## Product Change Notice (PCN)

PCN Number: PCN-65280402R-01

- VMS-300-x-y (x=12, 15, 24, 36, 48, 0512 or 1224; y=blank, CF or CFS) series
- VMS-300-Dx-y (x=12, 15, 24, 36, 48, 0512 or 1224; y=blank, CF or CFS) series

For U & CF type - Current terminal block-

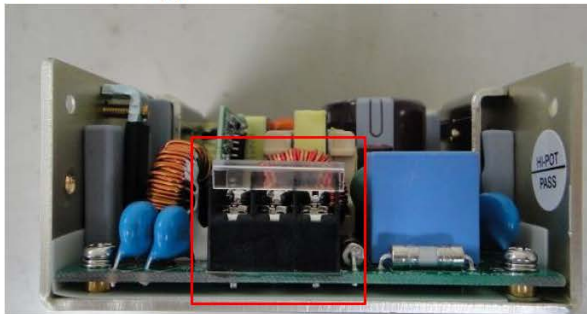
**Description of Change:** IEC 60601-1: 2005+ A1, EN60601-1: 2006+A11+A1+A12 requires input connector to have European approval (TUV, VDE or EN/EC etc.). The new connector, which meets European approval, does not have the plastic cover. See updates highlighted within Red squares in the images below:

New terminal block-
